From: McGuffie, Brianne E SPL [Brianne.E.McGuffie@usace.army.mil]
Sent: 7/25/2014 10:22:41 PM
To: Julie Vandermost [JVandermost@vcsenvironmental.com]; Tracey Brownfield [tracey@landveritas.com]; Nate Bello [bello@wra-ca.com]; Tim DeGraff [degraff@wra-ca.com]
CC: Swenson, Daniel P SPL [Daniel.P.Swenson@usace.army.mil]; Pankratz, Shannon L SPL [Shannon.L.Pankratz@usace.army.mil]; Allen, Aaron O SPL [Aaron.O.Allen@usace.army.mil]; Zimmerman, Jan@Waterboards [jan.zimmerman@waterboards.ca.gov]; dlawhead@dfg.ca.gov; Amato, Paul [Amato.Paul@epa.gov]
Subject: Corps comments (UNCLASSIFIED)
Attachments: Ecoregions_SoCal_Omernik Level IV_85.gif; Ecoregions_SoCal_Omernik Level IV_8.gif; Peterson Ranch bank_service area_v02_L4 ecoregions_v02.pdf

I apologize for the delay in getting these comments to you. I believe Paul copied you on his comments already, but below are Corps comments (in bold).

Peterson Ranch SA (as in sponsor's 7/15 IRT meeting submittal) with Omernik level IV ecoregions.

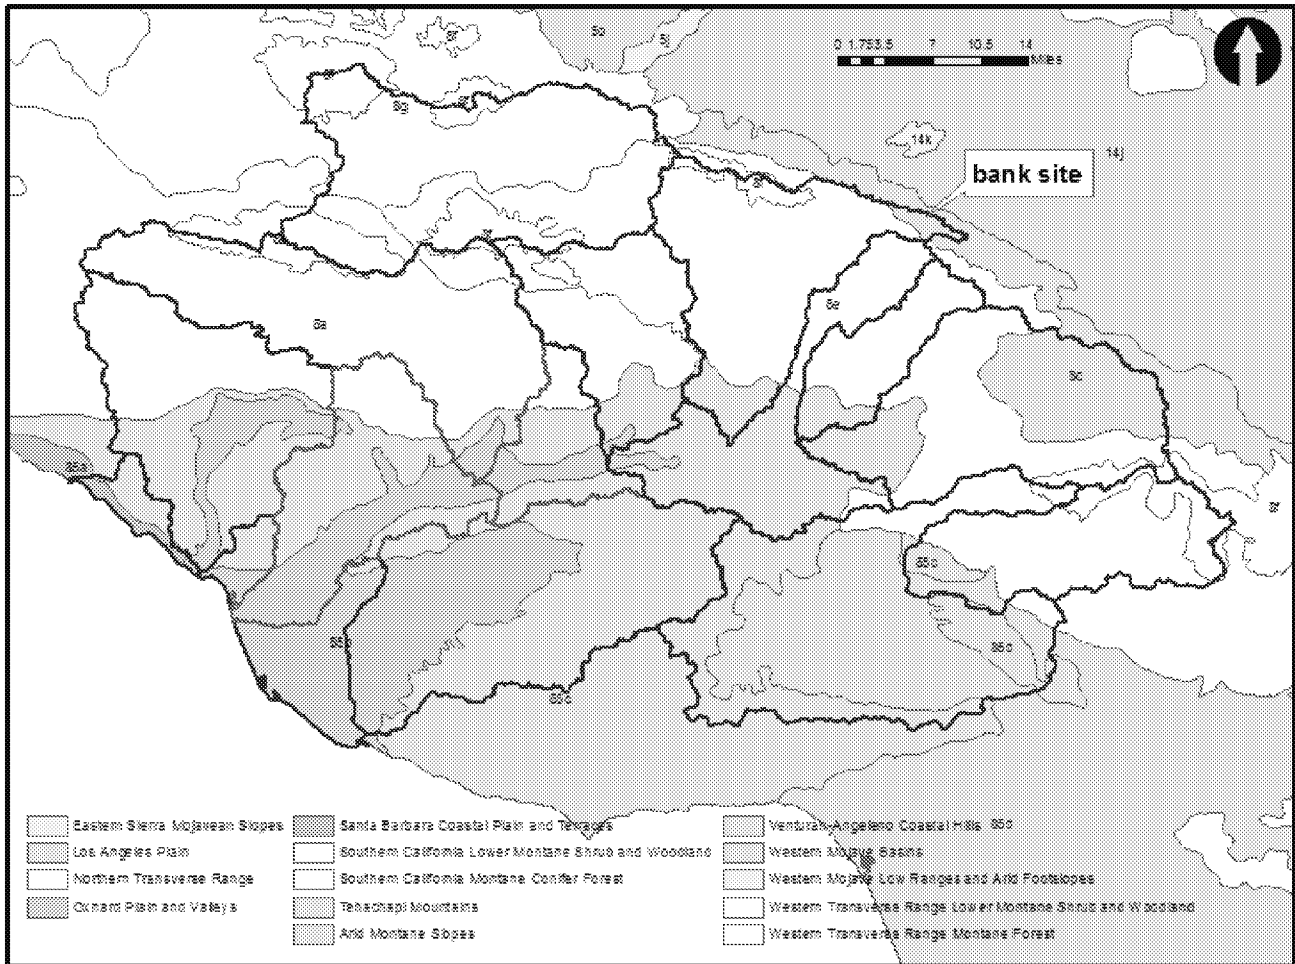
***Corps comment #6/WRA Response: The new SA map doesn't show all the Omernik Level IV (most detailed) ecoregions, So Dan created a map that does (below and attached). For example, the bank site appears to be within or near 8c (Arid Montane Slopes) and/or possibly 8e (SoCal lower montane shrub and woodland). The current proposed SA (primary = red, secondary = blue, tertiary = purple) shows that level IV ecoregion varies quite a bit within the proposed service area. Although I'm not that familiar with these ecoregions, it seems some of these are substantially different from those of the bank site itself. We should consider whether all these should be in the SA. For example, the upper LA HUC is mostly Los Angeles Plain (probably very different) whereas the Big Tujunga Creek HUC is mostly SoCal lower montane shrub and woodland which is contained by or at least near the bank site. The Sespe Creek HUC, the northern part of the Upper Piru Creek and Ventura River HUCs, and the coastal HUCs are also different in terms of ecoregion. [please note: the attached ecoregion gifs show the codes together with text names, but the colors do not match my map below]**
